TECHNICAL PRODUCT BULLETIN TB-2024-01-01 Rev A

Subject: Shipper Core Changes

Shipper Core Designs:

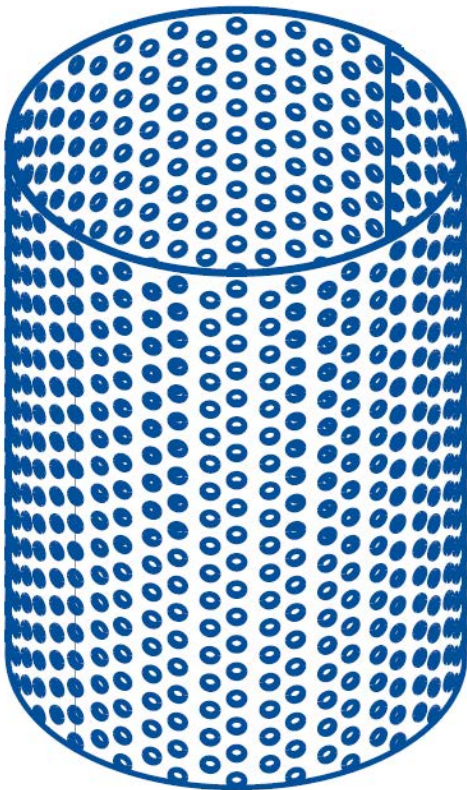
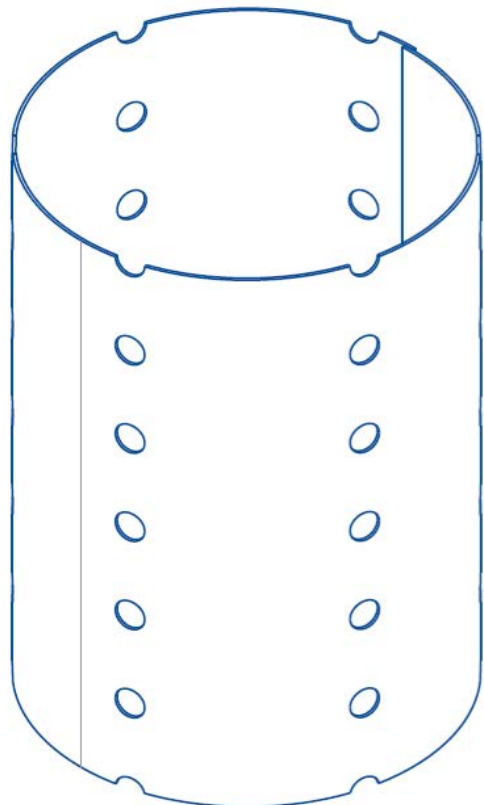
During the year of 2024, IC Biomedical will be making a design change to the shipper cores in all 10DX and Dual units. The previous design uses an aluminum mesh screen. The new design uses a rolled aluminum sheet with larger holes to allow for LN2 absorption. Functionally, there is no difference in absorption rate, NER, or hold time between the two designs.
